MISSISSIPPI POWER & LIGHT COMPANY

SUBJECT: Grand Gulf Nuclear Station  
Units 1 and 2  
Docket Nos. 50-416 and 50-417  
File 0260/8010/L-334.0/  
L-350.0/L-860.0  
Fire Protection, Revised  
FSAR 9.5 and 9A  
AECM-82/324

A summary description of the proposed changes is provided for your information as Attachment 1 to this letter. The proposed changes are provided as Attachment 2 and are intended for FSAR Amendment 56, scheduled for August, 1982. The entire Section 9.5.1 and Appendix 9A, including revised and unrevised text pages, are included for your convenience. Changes are indicated by change bars in the margin.

Figure 9A-55

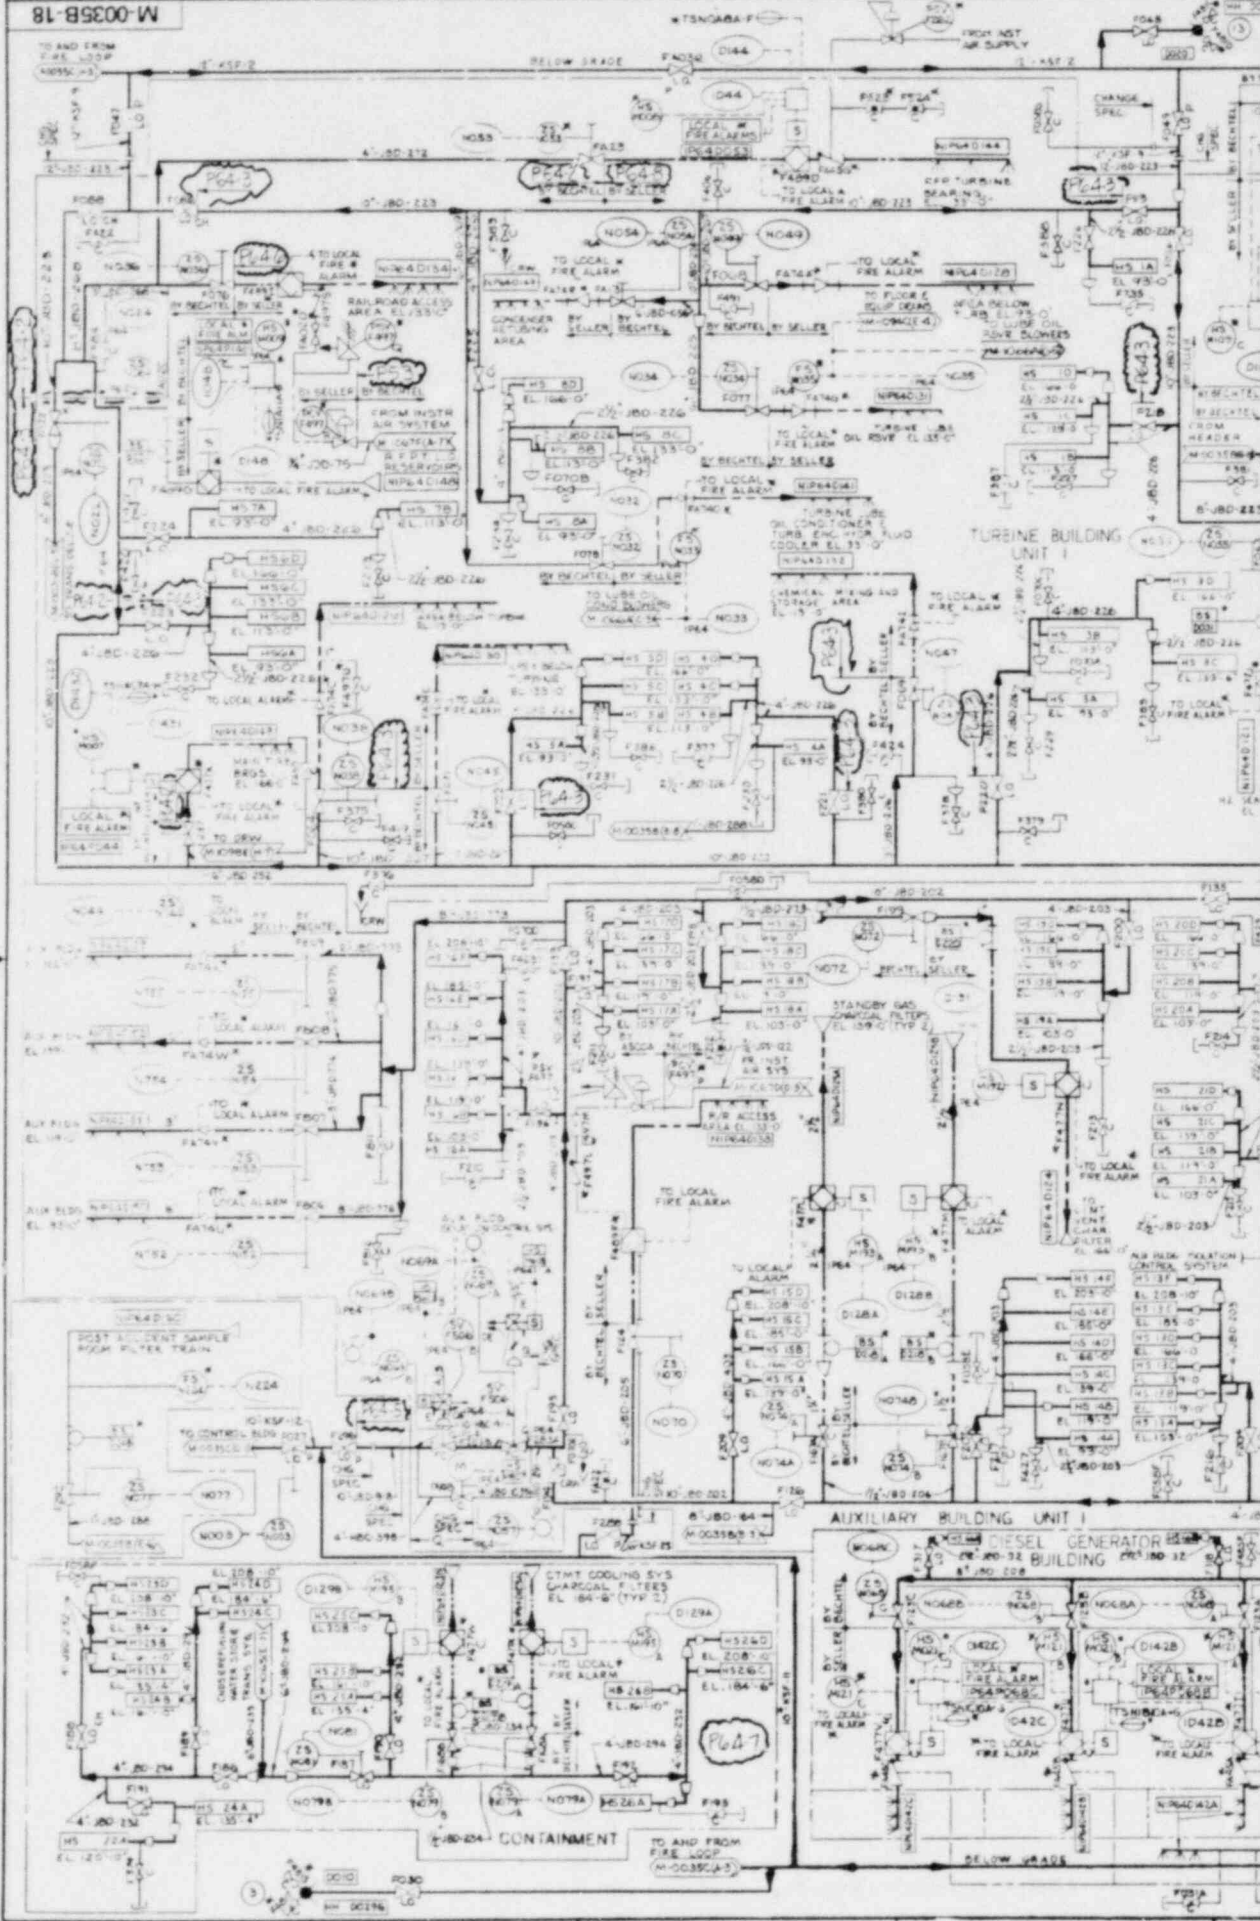
- a. A complete copy of text pages (revised and unrevised) to FSAR Section 9.5.1 and Appendix 9A.
- b. Copies of revised FSAR Figures 9.5-2, 9.5-4, 9A-3, 9A-4, 9A-16, 9A-17, 9A-22, 9A-28, 9A-29, 9A-30, 9A-32, 9A-33, 9A-36, 9A-38a, 9A-38b, 9A-40, 9A-42, 9A-43, 9A-45, 9A-46, 9A-47a, 9A-47b, 9A-48, 9A-49, 9A-50, 9A-51
- c. New FSAR Figure 9A-55
- d. Revised FSAR Q&R Page 9A-27

As may be noted in Figure 9A-55, the auxiliary building north, south, and east corridors at elevations 93' and 103' actually contain two rooms in each corridor, 1A117 and 1A123, 1A114 and 1A122, and 1A101 and 1A121, respectively. Architecturally, rooms 1A123, 1A122, and 1A121 extend from the elevation 103' grating to the overhead (E.L. 116'-7½"), and rooms 1A117, 1A114, and 1A101 extend from the elevation 93' slab to the grating. Exposure fire areas located above the 103' grating have the same vertical boundaries as the corresponding architectural rooms. However, because the open grating utilized as a 103' elevation floor will not inhibit the effects of an exposure fire, exposure fire areas below the grating include the space of the 103' elevation area directly above.

**FIGURE 9.5-4**

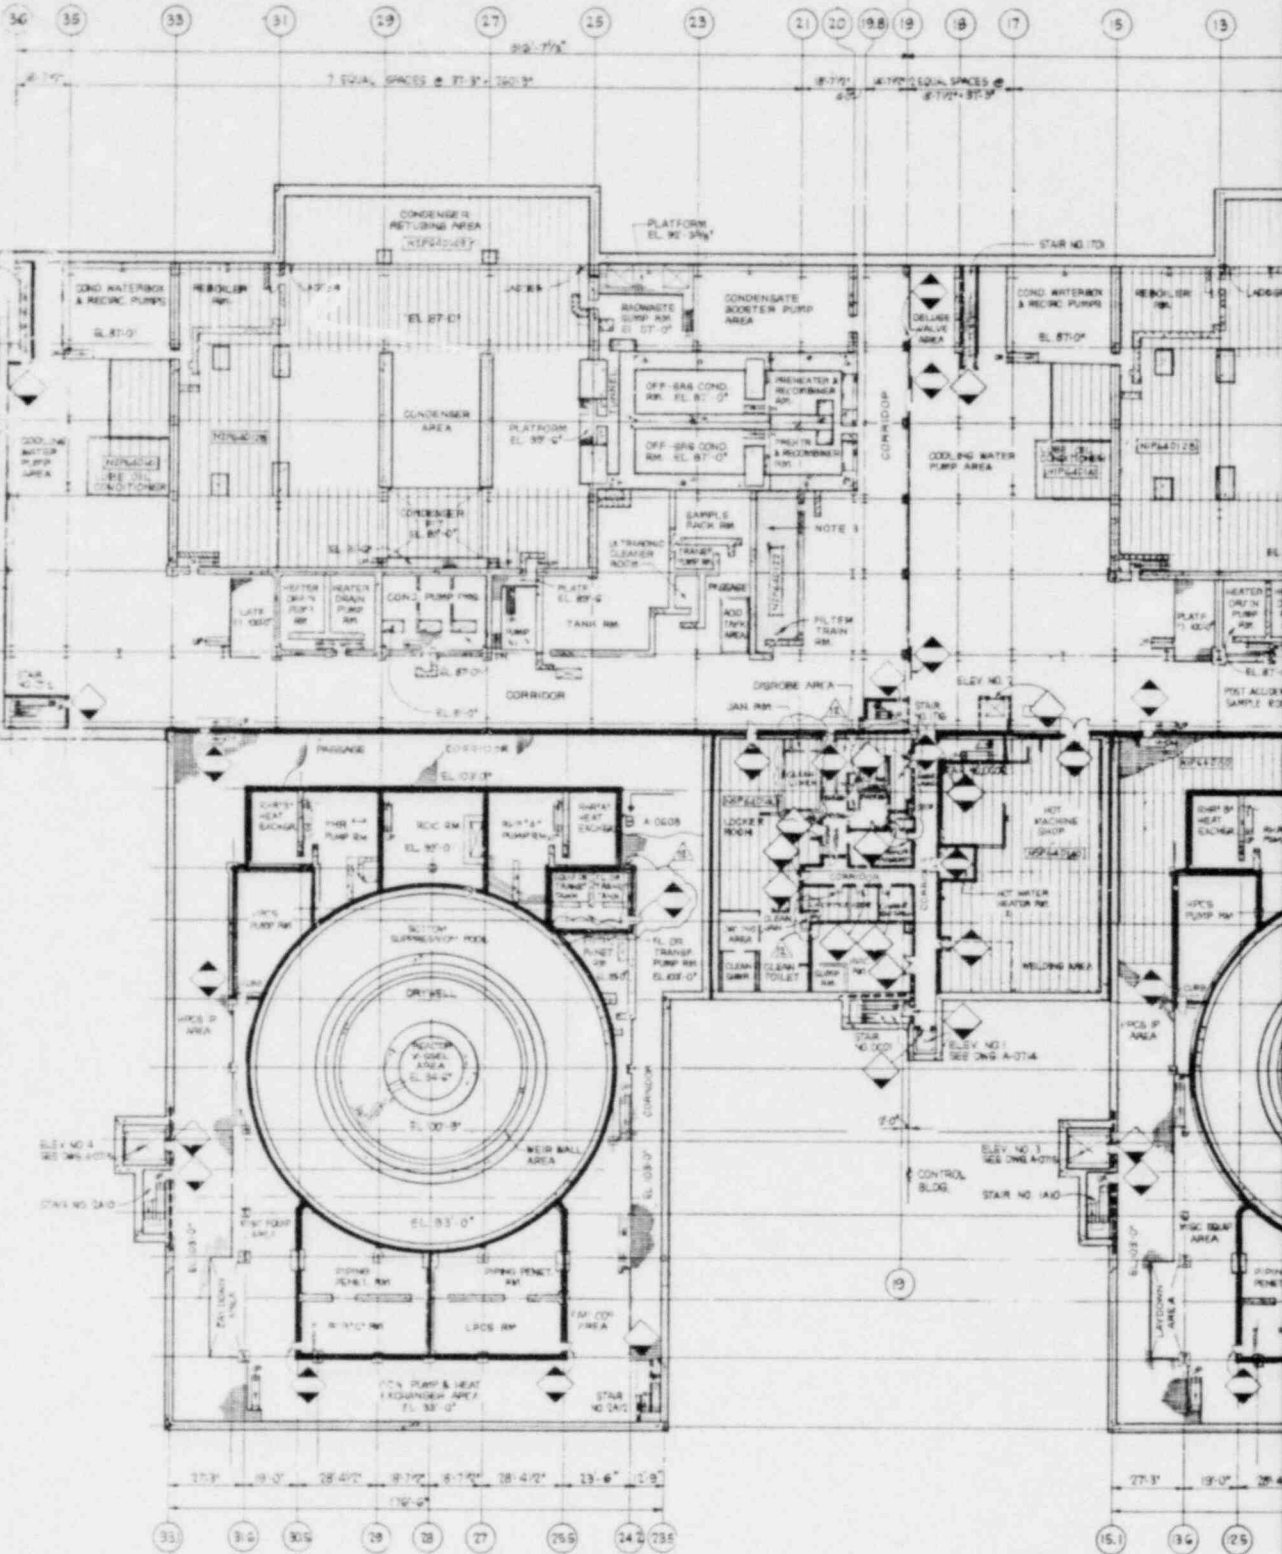
- b. Appendix 9A, Section 7.2 and Table 9A-2 have been revised, as necessary, to indicate that hose streams and fire extinguishers are not necessarily in a given room but are accessible to the room. Figure 9.5-4 provides actual locations for hose stations and extinguishers.

FIGURE 9A-3

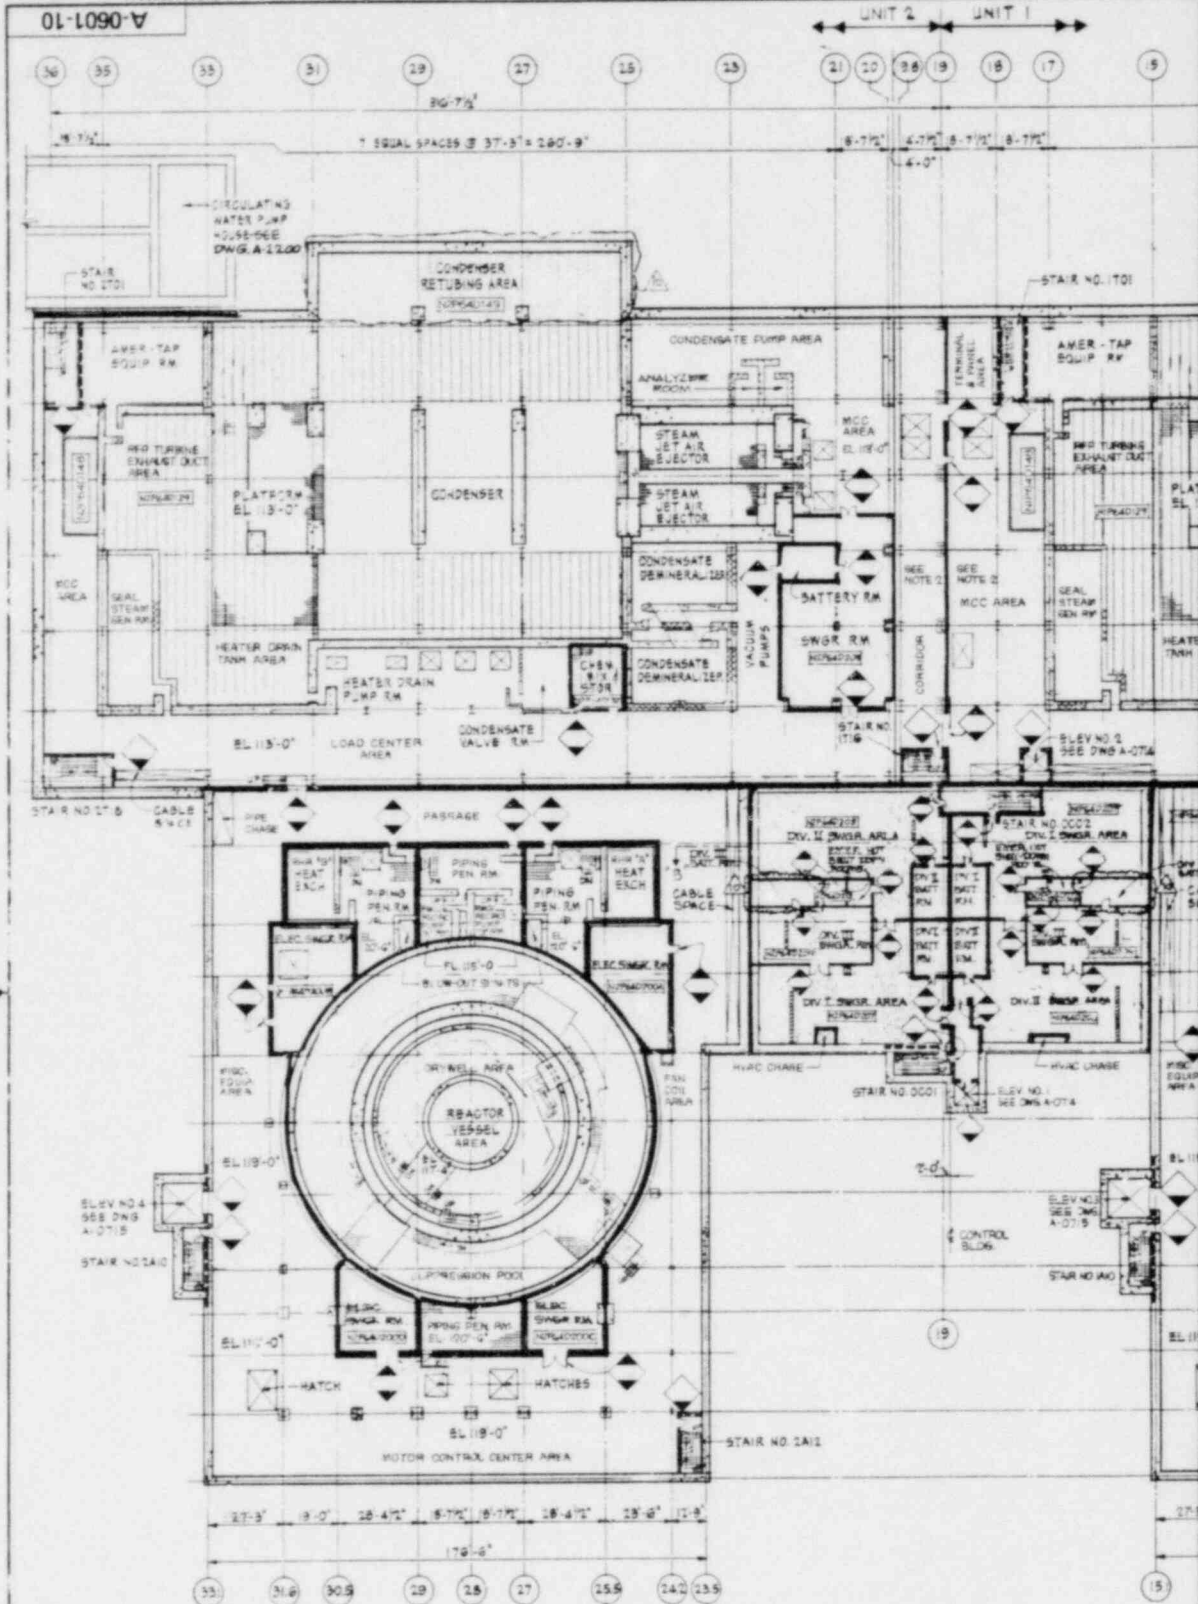
- g. Table 9A-2 has been revised, as necessary, to clearly indicate the fire rating of walls that enclose a given area. Rated fire barriers are shown on Figures 9A-3 through 9A-9.

Since this area contains redundant safe shutdown-related cables in proximity to one another, the following fire protection measures have been provided: area coverage by ionization smoke detector(s), 1-hour fire barriers to isolate Division I from Division II cables, and a wet pipe sprinkler system covering the passage from column line G.4 to the east wall (column line G) and column line 10.5 to the north wall (column line 15.1) as shown in Figure 9A-3.

**FIGURE 9A-4**

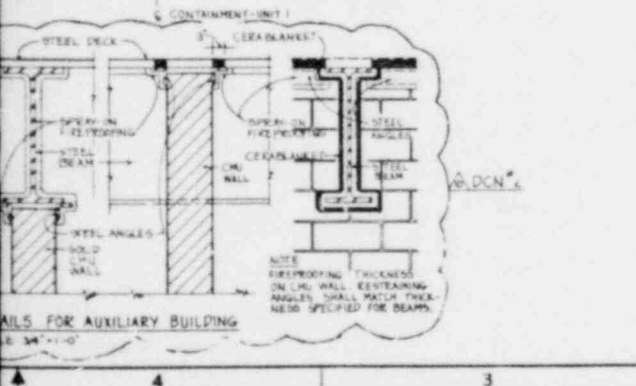
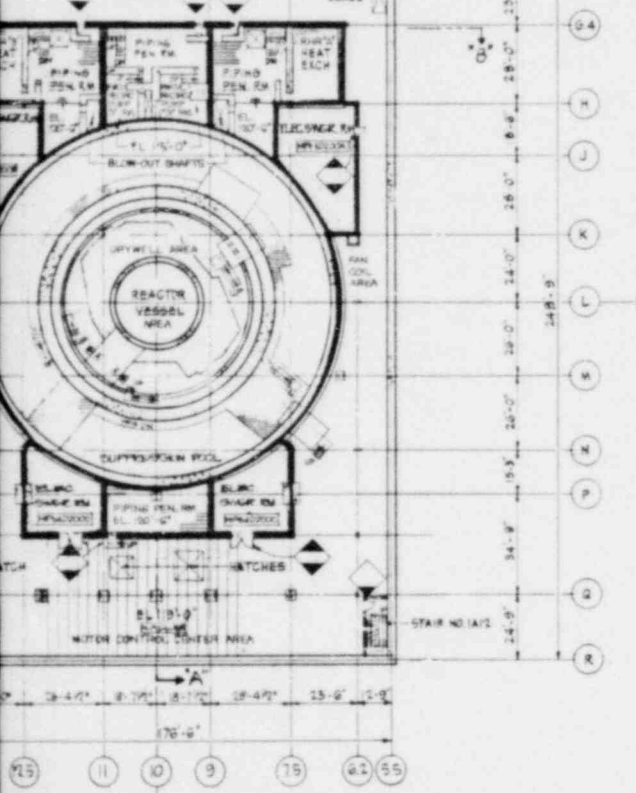
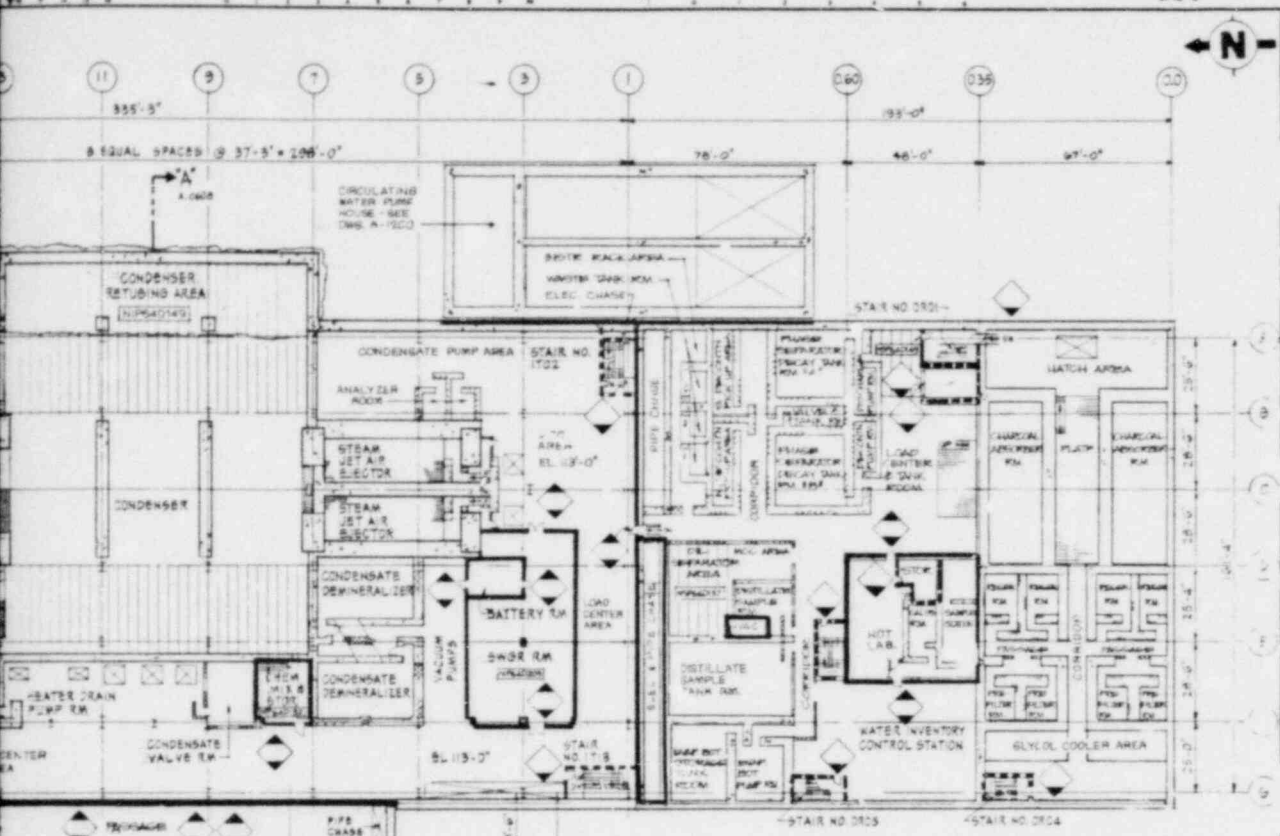
Safe shutdown-related cables in Area 1A211 are routed as close as 5 feet from redundant cables in Area 1A201. Based on the criteria described in subsection 7.1.5, area coverage by ionization smoke detectors, one-hour fire barriers to isolate the redundant cables from one another, and an automatic wet pipe sprinkler system have been provided to ensure that no single exposure fire will affect the safe shutdown capability. The sprinkler system covers the passage from column line J.5 to the east wall (column line G) and column line 13 to the north wall (column line 15.1), as shown by Figure 9A-4.
